## Note on using PRIMERGY TX150 S6

February 2008  
FUJITSU LIMITED

## 2. Updates for "PRIMERGY TX150 S6 User's Guide"

#### ■ Attaching covers (Page 116)

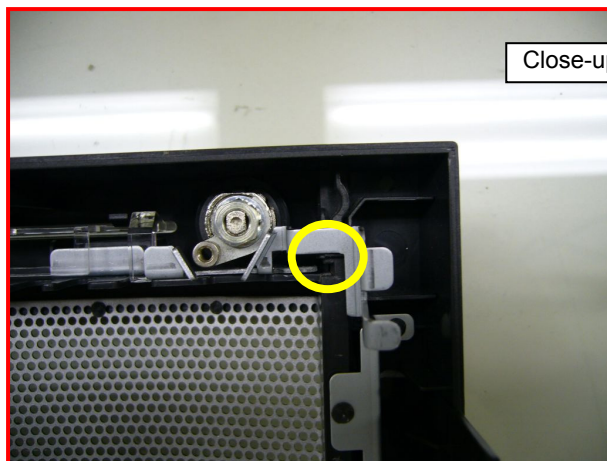
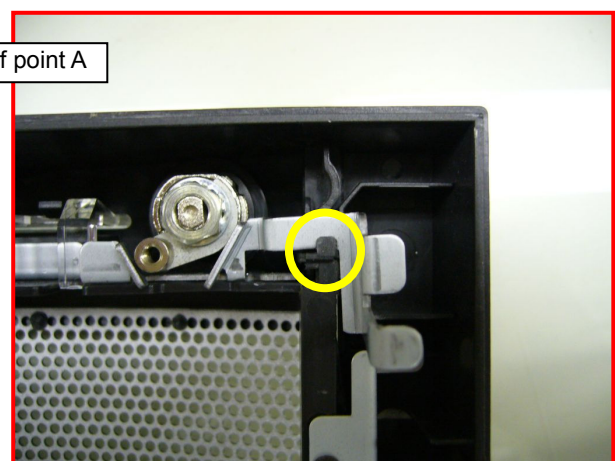
Following caution notes are added for attaching the cover description.

Before attaching the covers, flip the front cover and make sure the position of the key lock part (Point A) is settled at the *proper position*. If the key lock part is not at the *proper position*, resetting the part before attaching the covers are required. It may cause a breakage failure if you attach the covers and lock the key with wrong position.

Improper Position

Key lock part is unhooked (yellow circle).

Proper Position

Key lock part is hooked.
